Architects Supplemental Instruction (ASI)

Project: West Birch Apartments and Townhomes	ASI #: 01
Owner: West Birch Estates of Princeton	Date of Issuance: 09/26/19
To: Lumber One Avon	Architect's project #: 616-18

The intent of this ASI is to amend the Project Documents to incorporate various VE items which were unintentionally omitted in previous document revisions. It is not expected that any of the included items will have any impact on current Project Pricing.

1 WALL SECTION - 2
1/2" = 1'-0"

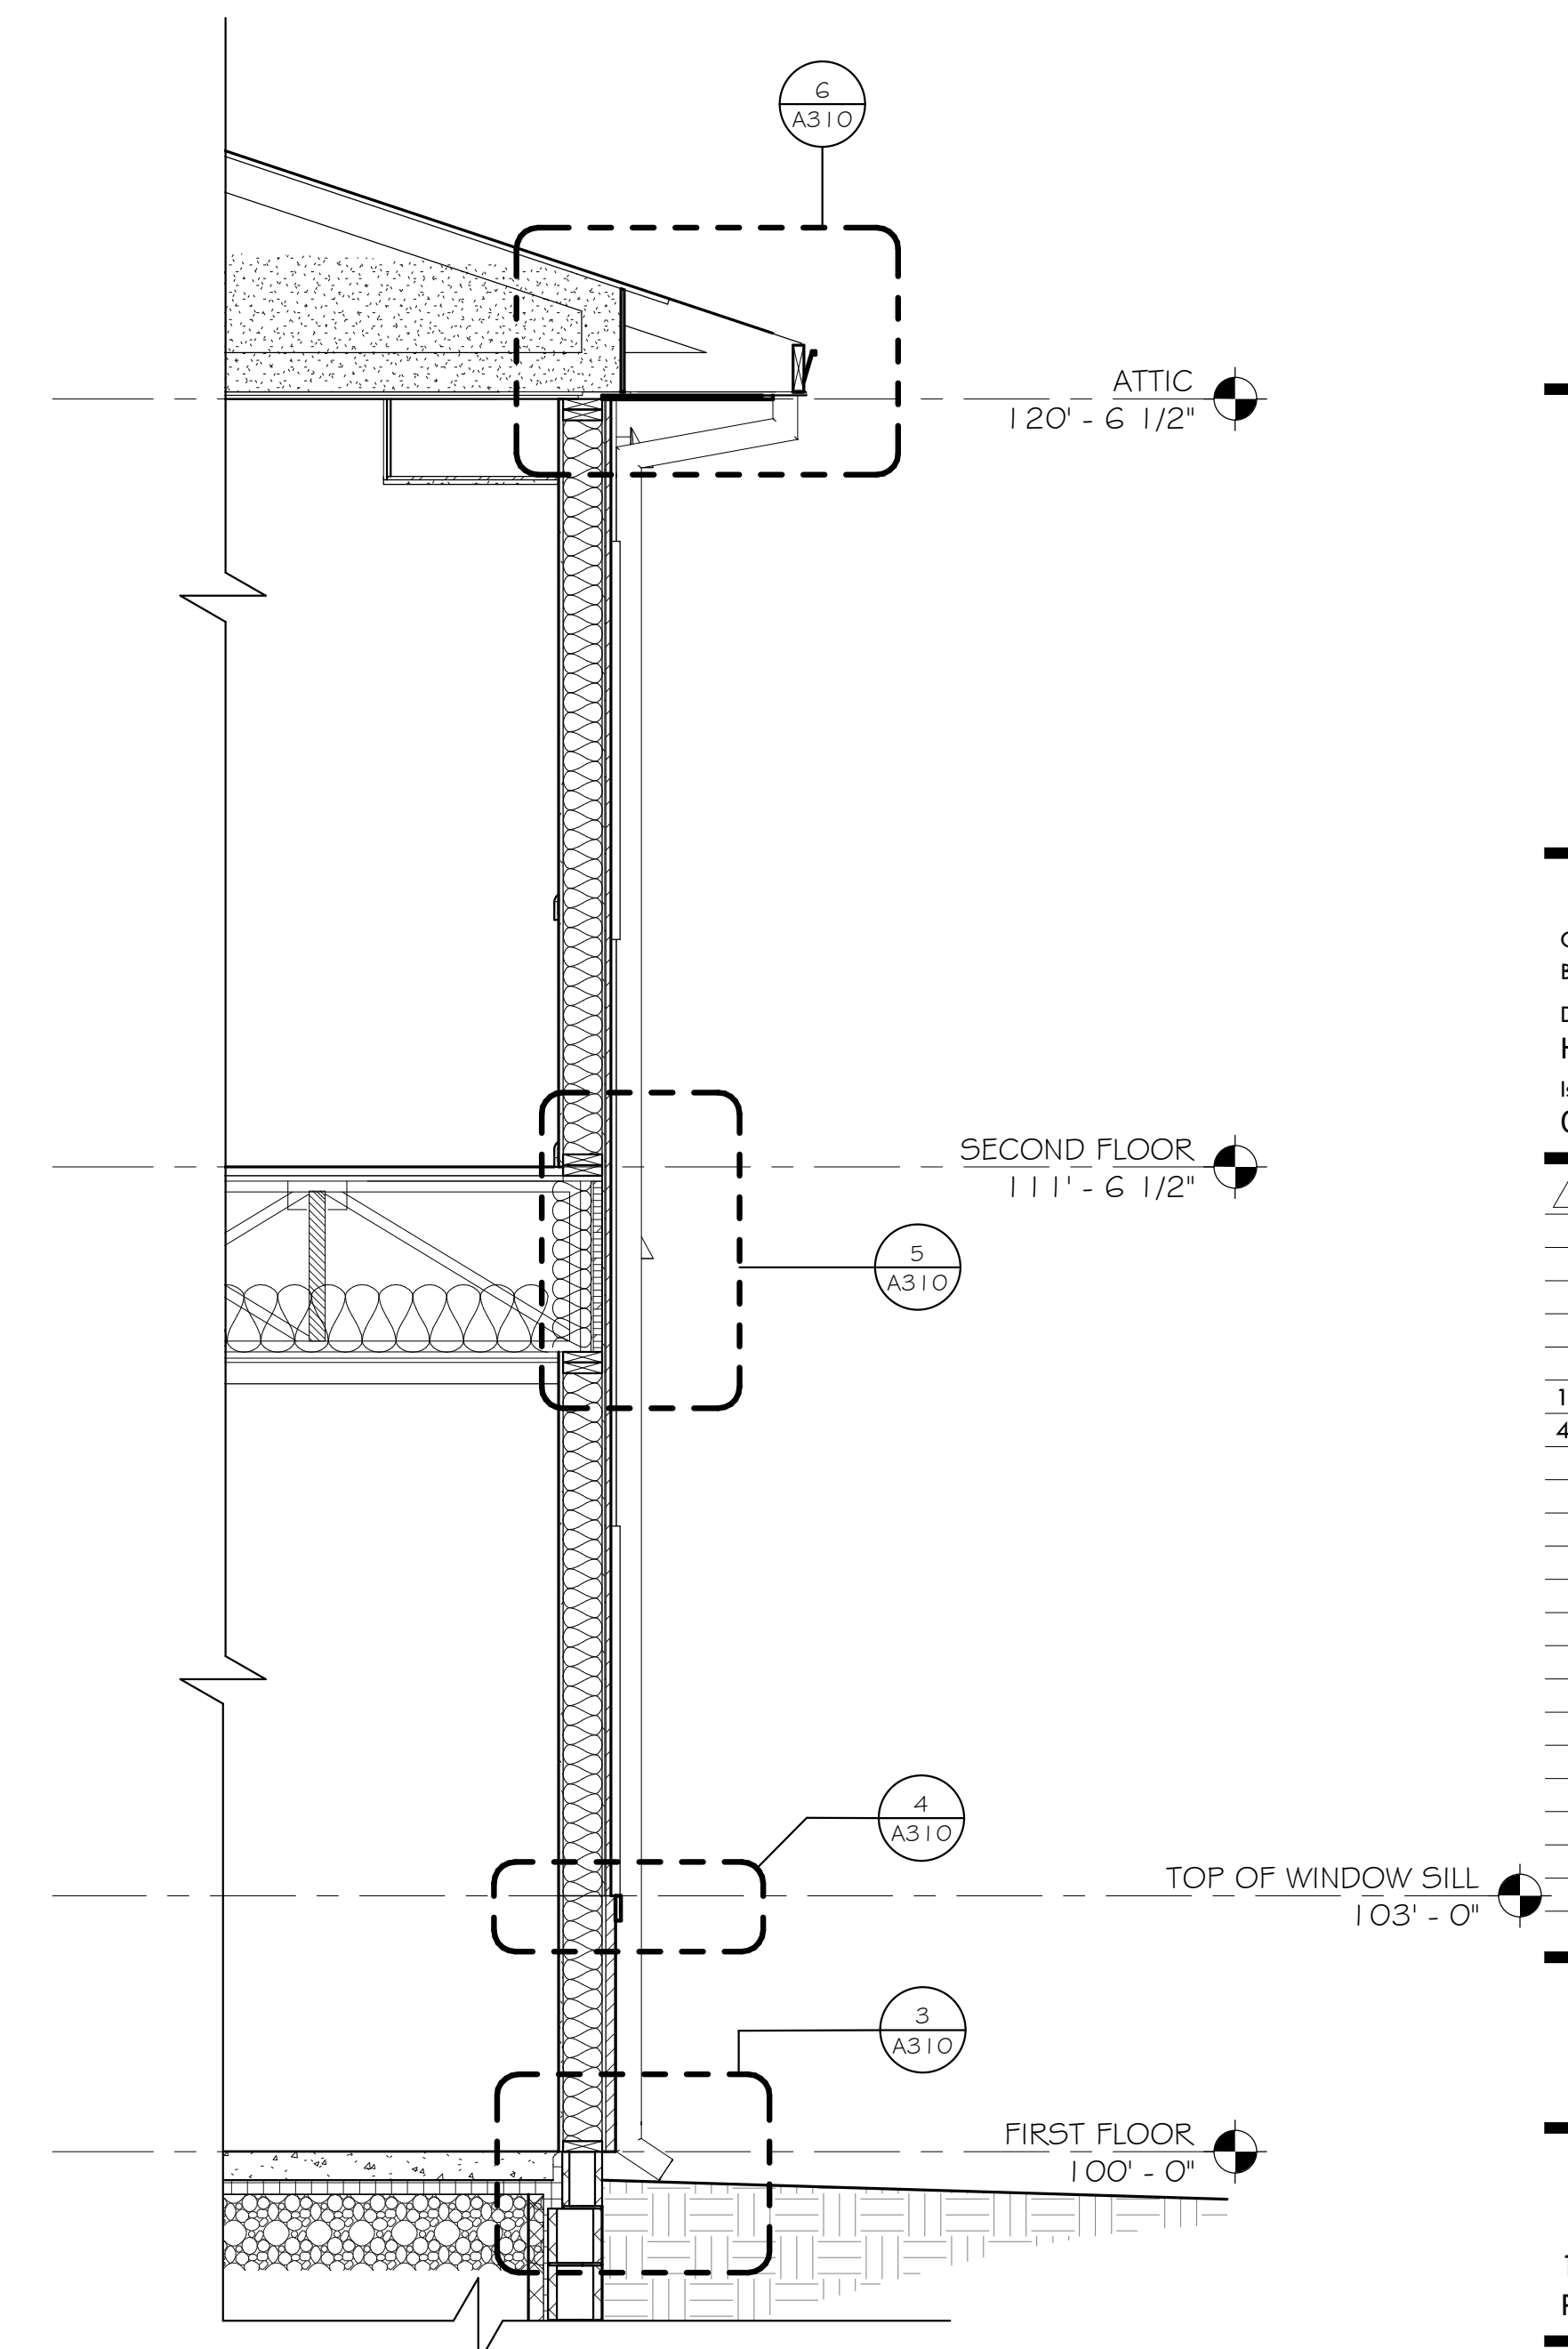
1. Removed text notes referring to cellular PVC trim and replaced them with text notes referring to steel clad trim. Refer to the following sheets (Attached):
 - a. Sheet A310 – Wall Section – detail 2/A310
 - b. Sheet A602 – Exterior Details – Detail 3/A602
 - c. Sheet A603 – Exterior Details at Openings – 2/A603, 4/603
2. Removed medicine cabinets. Refer to the following sheets (Attached):
 - a. Sheet A410 – Enlarged Plans – Unit Types A, A.1, B, & F - Detail 1/A410, 2/A410, 3/A410
 - b. Sheet A411 - Enlarged Plans – Unit Types C, C.1 & D – 1/A411, 2/A411
 - c. Sheet A412 - Enlarged Plans – Unit Types E (ACC) & C.2 (ACC) – 2/A412, 4/A412
